K95KNGM800 Class II Permissive Change Request – Circuit Change Description

Applicant: RELM Wireless Corporation
FCC ID: K95KNGM800

Figure 2 – Transmitter with Changes to Support Emissions Designator 8K10F1W

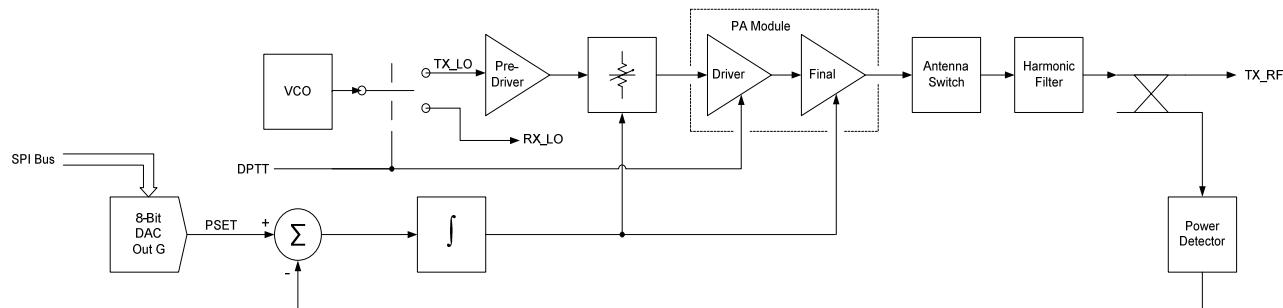
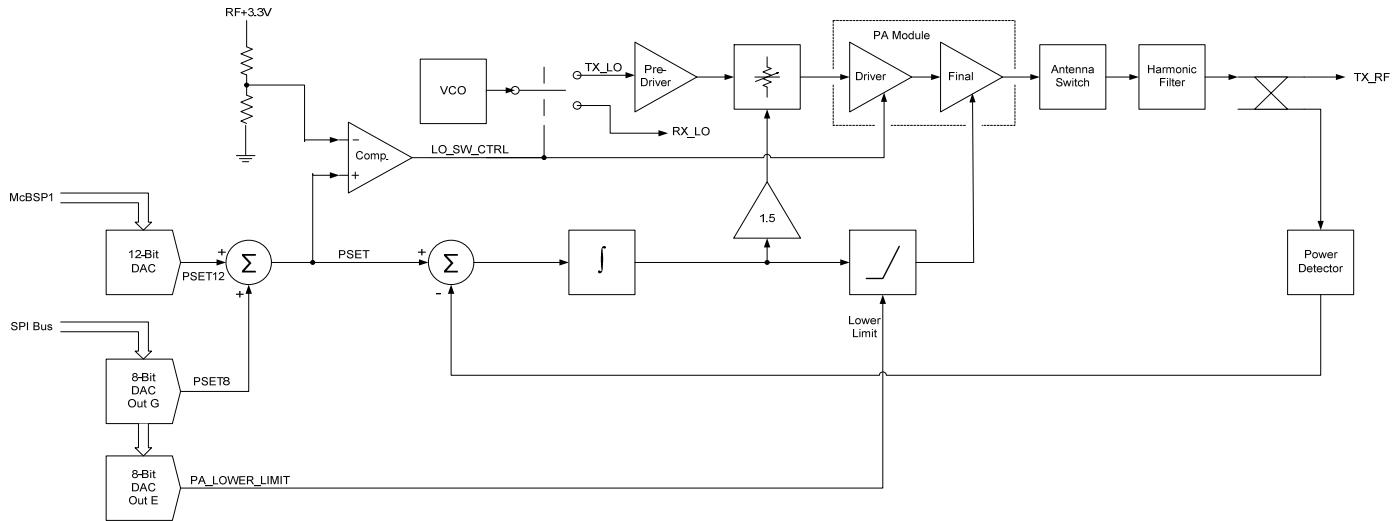
The following circuit change has been made to FCC ID K95KNGM800 under the Class II Permissive Change guideline for this FCC ID to have P25 Phase II Operation incorporated; thus, requiring Emissions Designator 8K10F1W to be added.

Some changes to the transmitter power control circuitry are required in order to support the more accurate power ramping required for P25 Phase II operation (emissions designator 8K10F1W). These changes consist of: the addition of a 12-bit DAC to set power, the addition of a comparator to control the existing RX/TX LO switch, and the addition of a limiter amp in the Final Stage gate bias path to allow a software-controlled lower limit to be set during TDMA transmissions. Figure 1 below shows a block diagram of the transmitter as it was when the K95KNGM800 type acceptance was granted and Figure 2 shows a block diagram of the transmitter with the changes required to support emissions designator 8K10F1W. No changes have been made to the synthesizer, VCO, pre-driver stage, driver stage, final stage, antenna switch, harmonic filter or directional coupler. None of the changes will affect maximum output power.
